Seattle Light Rail Review Panel

APPROVED MEETING MINUTES

November 20, 2014

Roosevelt Station Art

Details of Luca Buvoli’s proposed artwork for the east and west walls of the station platform.

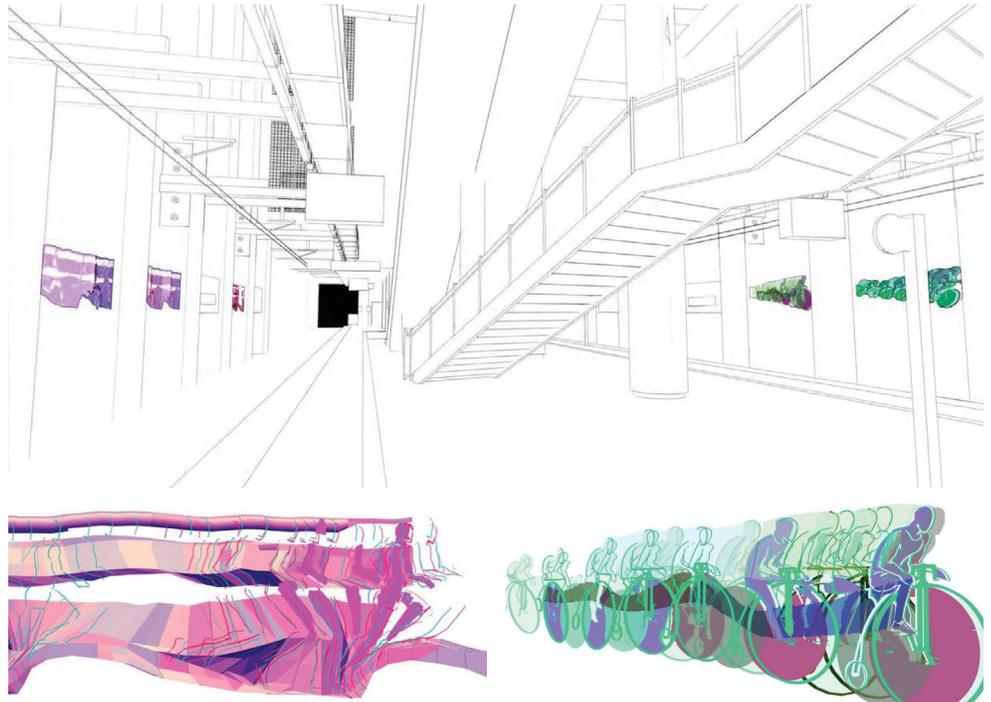
The LRRP responded positively to Luca Buvoli’s work. The discussion centered on how Mr. Buvoli could take his concept even further, particularly at the platform level. The panel members found Mr. Buvoli’s artwork most successful where it breaks away from the plane of the architecture and, accordingly, encouraged him to increase that quality along the platform. The LRRP suggested exploiting the rhythm of the pilasters, gathering all pieces in a large vertical piece in one central bay of the platform wall, or creating more three-dimensionality so that the artwork is glimpsed from the mezzanine and descending the escalator. Given the cavernous space of the platform level, the LRRP believed this artwork should be a significant piece that demands attention.

Elevation of "Bikers" installation along the wall at the platform level.

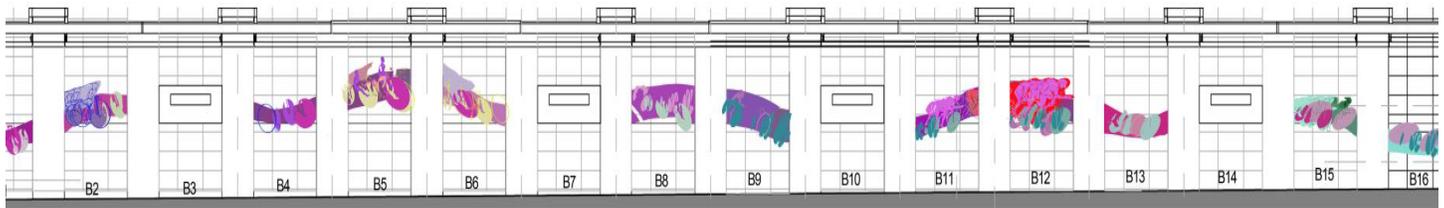
- At the platform level, explore breaking the rhythm of the pilasters in order to accentuate the artwork. You could achieve this by expanding the artwork verticality or altering the three-dimensional articulation and rotation of the planes of material. Explore ways to use the full depth of the pilaster.

The LRRP discussed the mix of rectilinear and circular geometry in the plaza.

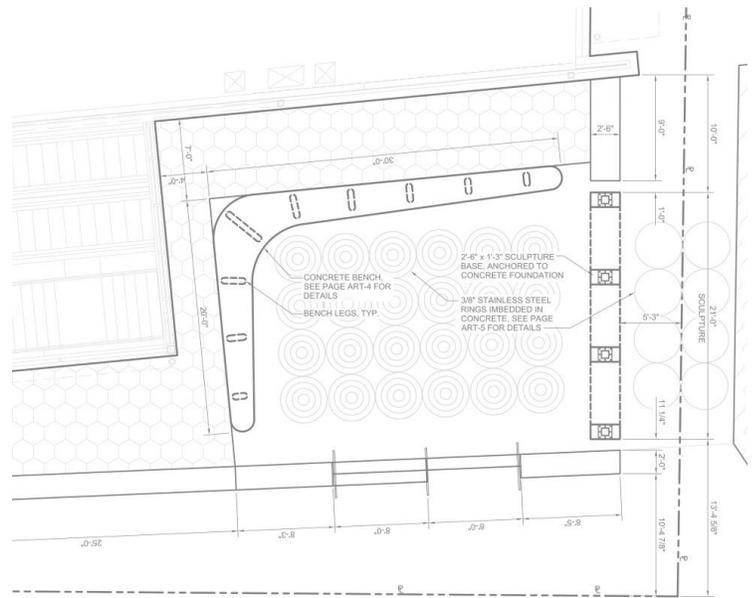
- Continue to explore providing seating with an obvious bench as proposed or, alternatively, as an organic shape that accommodates seating.
- Explore how geometry can create a more coherent space. Currently the relationship of rectilinear vertical elements and circles on the ground plane feels problematic.

- Reexamine the design and/or scale of the feet of the sculpture, which appear too small given the scale of the sculpture resting on them.
- Examine whether the concrete bench on NE 66th St at the northwest corner of the plaza is necessary and, if not, consider removing it or replacing it with planting to create a more welcoming edge.
